ICHD - ENVIRONMENTAL HEALTH DIVISION

SEPTIC: IMPROVEMENT PERMIT / AUTHORIZATION TO CONSTRUCT / OPERATION PERMIT / EXISTING SYSTEM

PERMIT # 303285

SITE ADDRESS: 160 Morning Dove Ln, Statesville 28625

INITIAL SITE SKETCH

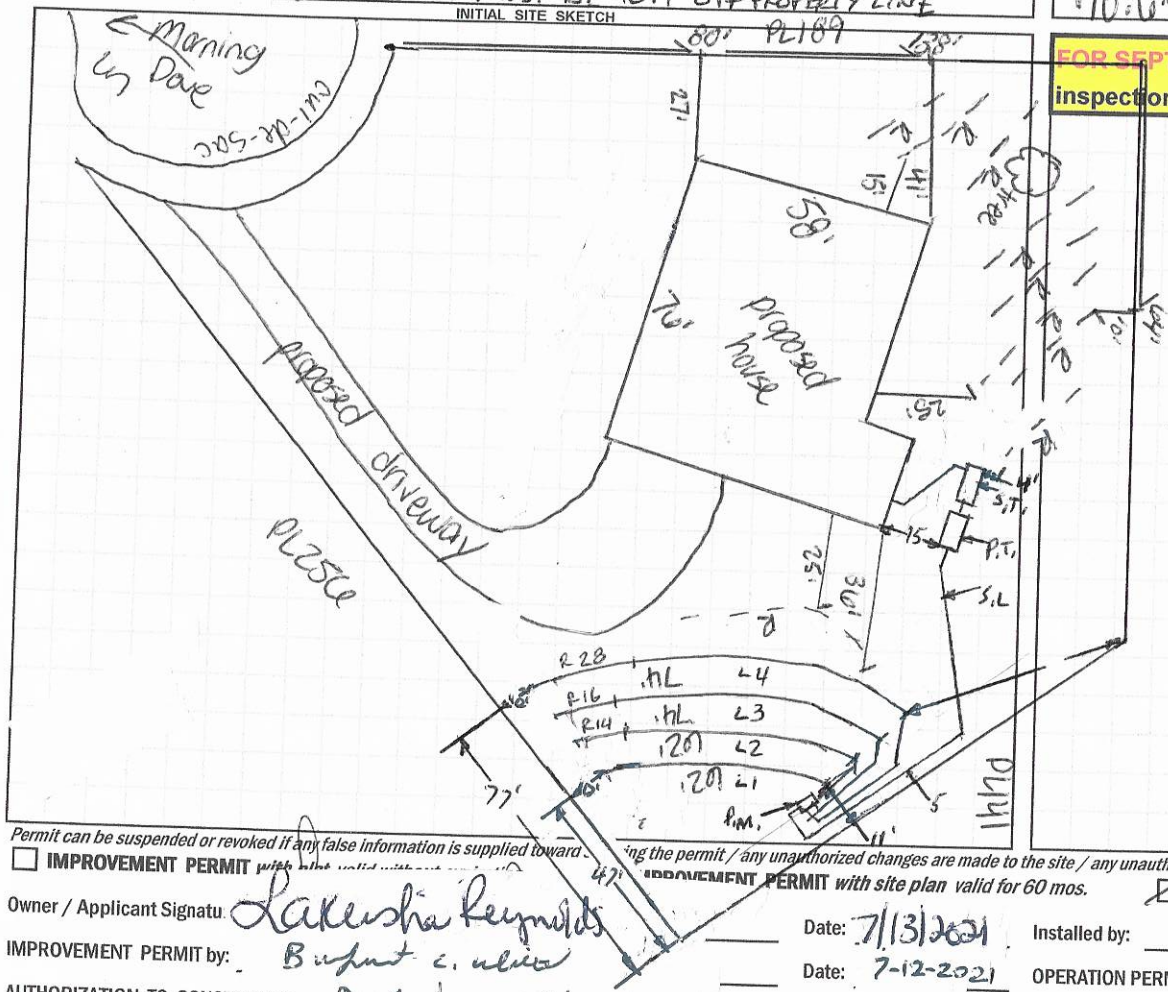
Comments / Conditions: Install on contour. Do not grade septic area. TANKS NOT TO EXCEED 36 IN OF COVER OR TRAFFIC RATED TANKS ARE REQUIRED, PRESSURE MANIFOLD MUST BE 10FT OFF PROPERTY LINE

- 42 panels
- 223.2 gal dose
- 10:1" drawdown
- TAPS L1=½ SCH80, L2=½ SCH80, L3=½ SCH40, L4=½ SCH40
- GPM = 25.18
- RUN TIME = 9 MIN
- 2FT OF PRESSURE HEAD

USE THIS SPACE TO DRAW YOUR SITE PLAN

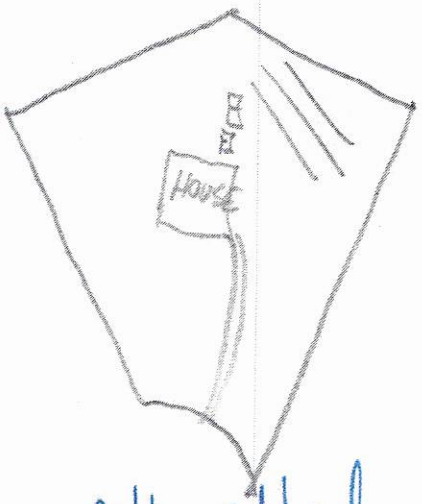
Hi,
attached you will find the new application for the redraw of the septic tank location. Originally the tank was to the front of the house and we want to move it to the right on back of the house .
Please call me at : 704-315-1684 Nick, for payment .
Let ,me know please if you have any questions.
Thank you !

INITIAL SITE SKETCH

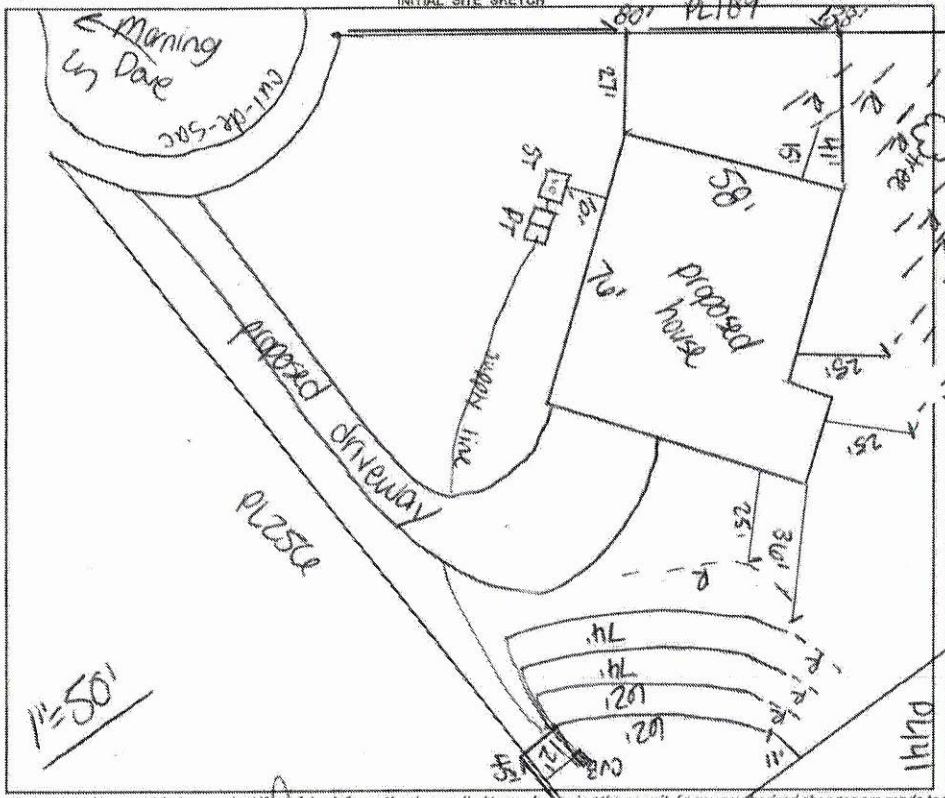
Comments / Conditions: Install on contour. Do not grade septic area. Supply line under driveway must be sleeved in ductile iron or buried 30".

- 42 panels
- 223.2 gal dose
- 10.6" drawdown

· 25.42 gpm
